Access Compliance Report

Public Rights-of-Way

(Curb Ramps)

Intersection ID: 52442	Main Street: WOODWARD_AV	Cross Street: BENDING_BIRCH_PL	Location: SE
ADA ID: C3C7C41C861F	Ramp Type: Directional1	Initial Pass/Fail: Pass	Overall Compliance: No
Severity Score: 15.25			
Codes/Mitigation Info/Possible Solution		Field Measurements/Component Compliance

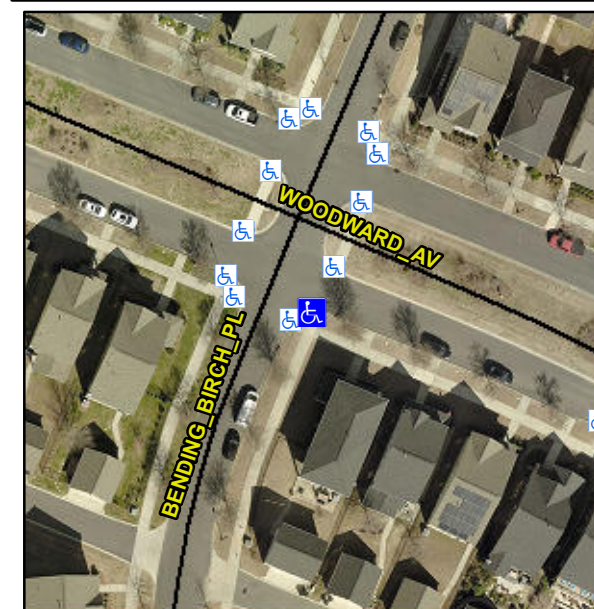
**R304.5.3, R304.2.2-Perp, R304.3.2-
Para, R305.2, R302.7.2**

Compliance	Description	Data	Compliance	Description	Data
N/A	Ramp Length (in)	81.0	Yes	Grade Break?	Yes
Yes	Ramp Width (in)	63.0	Yes	Grade Break Slope (%)	4.2
Yes	Ramp Slope (%)	5.5	No	Grade Break XSlope (%)	2.1
No	Ramp XSlope (%)	4.1			
Yes	Flare Type LT	N/A	Yes	Flare Type RT	N/A
N/A	Flare Slope LT (%)	N/A	N/A	Flare Slope RT (%)	N/A
N/A	Flare Traversable LT?	No	N/A	Flare Traversable RT?	No
Yes	Landing Length (in)	70.0	Yes	DWS Provided?	Yes
Yes	Landing Width (in)	76.0	Yes	DWS Contrast?	Yes
No	Landing Slope (%)	2.1	Yes	DWS Length (in)	24.0
No	Landing X Slope (%)	4.2	Yes	DWS Full Width?	Yes
N/A	Landing Curb? (Y/N)	N/A	Yes	DWS Offset LT (in)	12.0
N/A	Shared Landing?	Yes	No	DWS Offset RT (in)	3.0
Yes	Gutter Ponding?	No	Yes	Gutter Slope (%)	1.9
No	Gutter Lip Ht (in)	2.0	No	Gutter X Slope (%)	2.9
N/A	Painted X Walk1?	No		Road Slope (%)	5.3
	X Walk 1 Direction	To N		Road X Slope (%)	2.0
	X Walk 1 Width (in)	N/A		Clear Space?	Yes

**Remove & Replace Entire Ramp.
Remove & Replace Gutter.**
